ADDENDUM NO. 1

**DOCTORS HEALTHCARE AND
REHABILITATION CENTER**

BYSP PROJECT NO. 10106

16 SAW CUT DETAIL

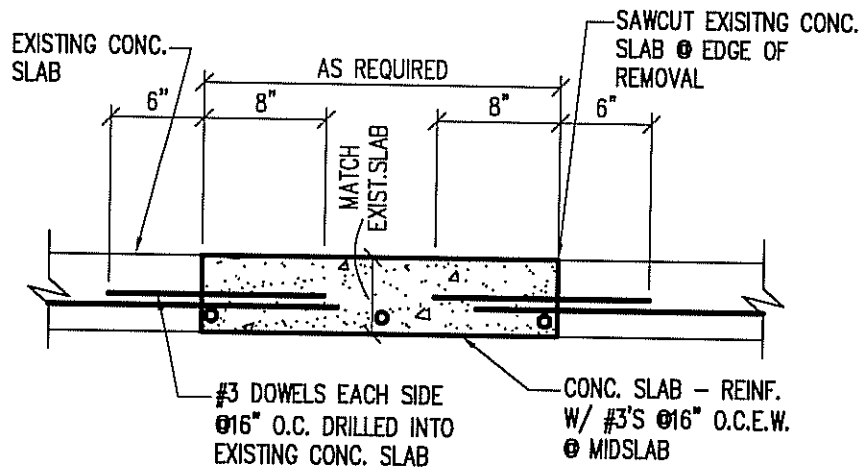
Sheet A101, A102: At GENERAL NOTES add the following note: F. WHERE SLAB SAW CUTTING OCCURS, REFILL WITH CONCRETE PER DETAIL 16/A406 (Detail included with this addendum.)

Sheet A406: Add Saw Cut Detail No. 16. See attached sheet A406.1.

17 COLUMN DETAIL

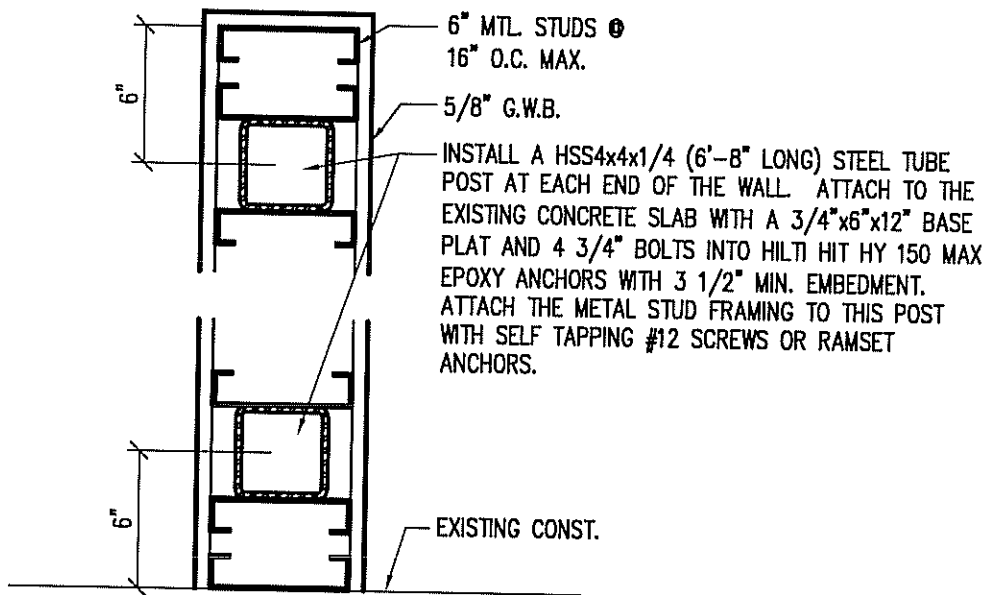
Sheet A406: Add Column Detail No. 17. See attached Sheet A406.2.

5 PARTITION SECTION

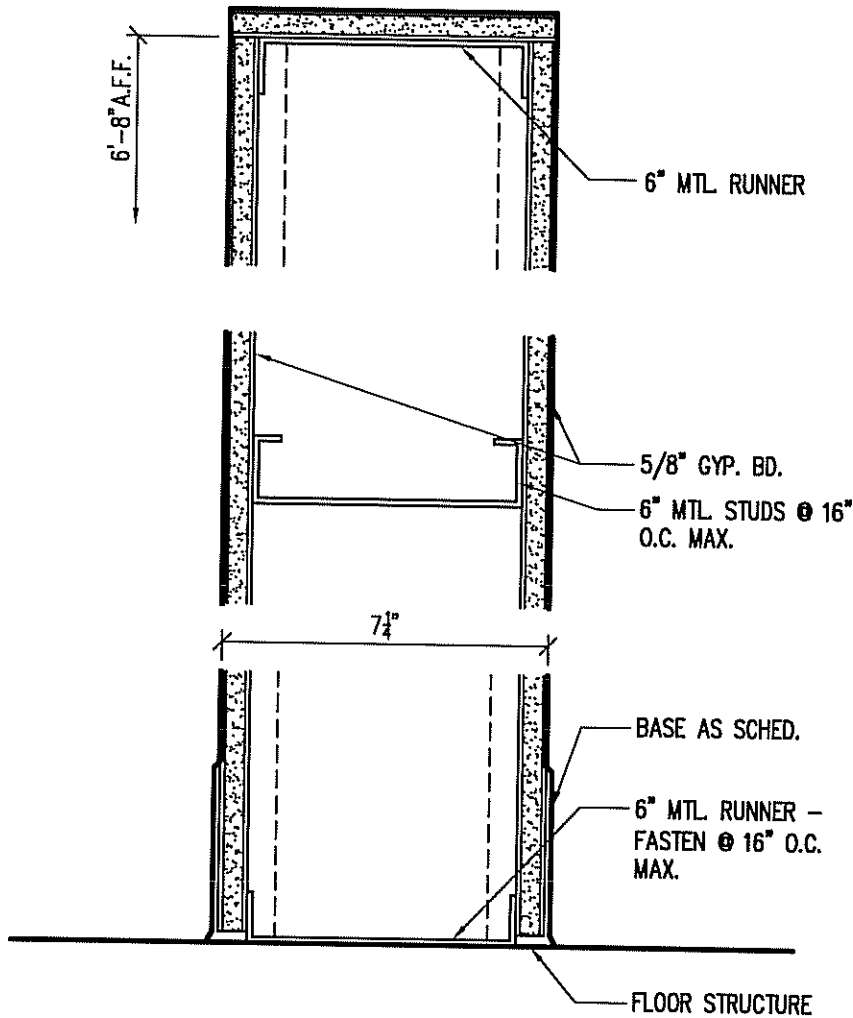
Sheet A407: Add Partition Section 5. See attached Sheet A407.1.

DRAWING NO. E102.1

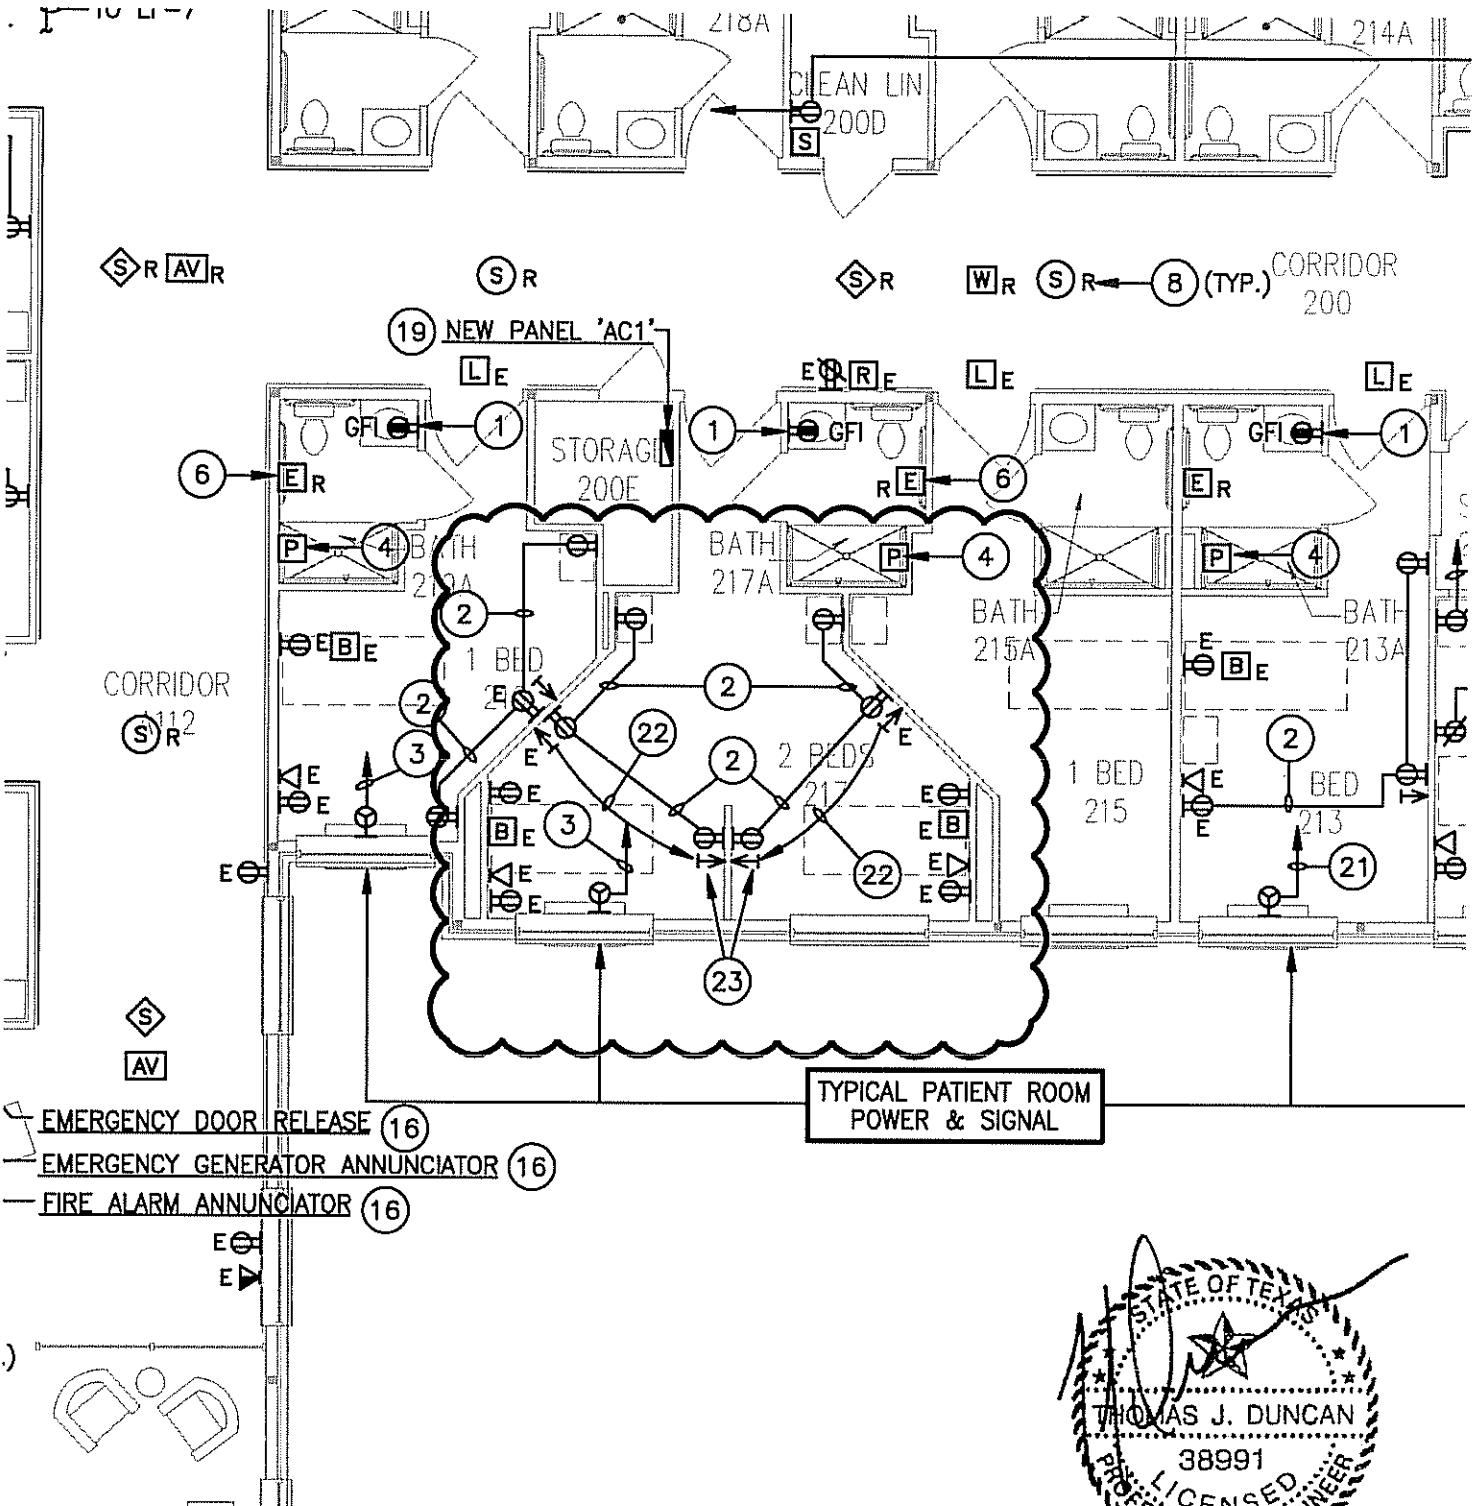
Sheet E102: Revise Lighting Plan as shown on attached sheet E102.1.
